RE: Second Engineering Review: P-26-002
Preliminary and Final Major Site Plan Approval
Owner/Applicant: Peninsula View Urban Renewal, LLC
75-87 East 31st Street
Block 411, Lot 2.01
City Of Bayonne, Hudson County, New Jersey

**RE: First Engineering Review: P-26-002
Preliminary and Final Major Site Plan Approval
Peninsula View Urban Renewal, LLC
75-87 E 31st Street
Block 411, Lot 2.01
City Of Bayonne, Hudson County, New Jersey**

Re: **PENINSULA VIEW URBAN RENEWAL, LLC**
258-270 PROSPECT AVENUE, *INTER ALIA*; BLOCK 411 LOTS 1-8, 10.01, 11-15
CITY OF BAYONNE (HUDSON COUNTY), NJ

STONEFIELD engineering & design	AFTON M. SAVITZ, P.E. 1500 BUCKLE, SUITE 201, N. 1574 UCHICAGO 7605100000, 904-688-	1" = 10' PROJECT NO. 3818	DL-23 VEHICLE CIRCULATION 2 OF 4
	SCALE TITLE	DRAWING

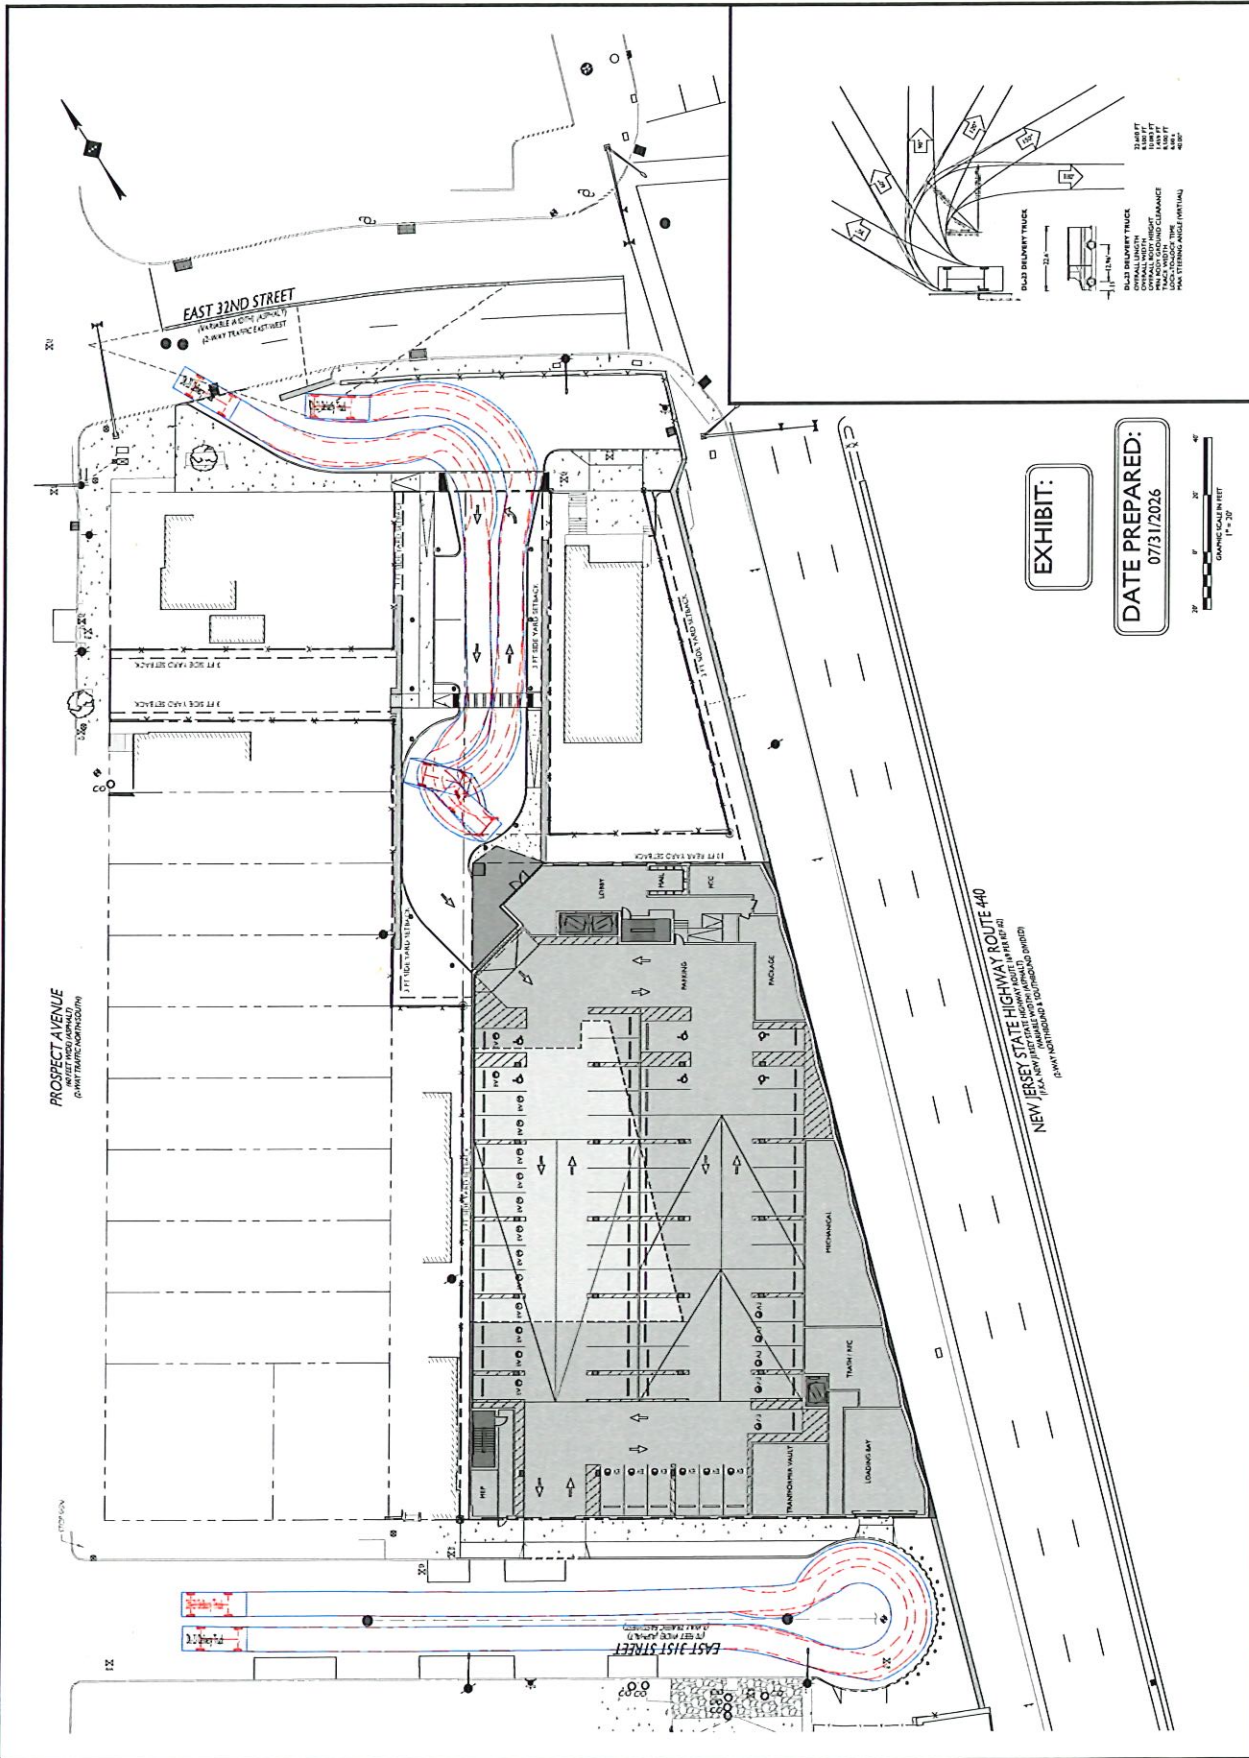
- Screening and Landscaping – The Applicant has proposed additional fence screening along the property's boundaries with adjoining residences and increases in streetscaping/landscaping.
- Internal Traffic Circulation – The Applicant has provided a Vehicle Turning Exhibit demonstrating that vehicles can enter the Site from E. 32nd Street intersection and return to the intersection. Passenger vehicles can execute the movement without "K-Turn" movements; however, larger vehicles (box trucks, fire trucks) must use a K-Turn movement. The Applicant has not demonstrated that vehicles can exit to the site to E. 32nd Street. An additional exhibit should be provided.

2. *Applicant to provide turning radius exhibits and testimony on ability to make the right run out of the property onto E32nd Street based on existing typical traffic at the E32nd Street and Route 440 intersection. Turning radius exhibits should consider both emergency access and typical package deliveries.*

A Vehicle Turning Exhibit is included with this response letter. Traffic Engineering Testimony will be provided during the August 11, 2026, Planning Board Hearing.
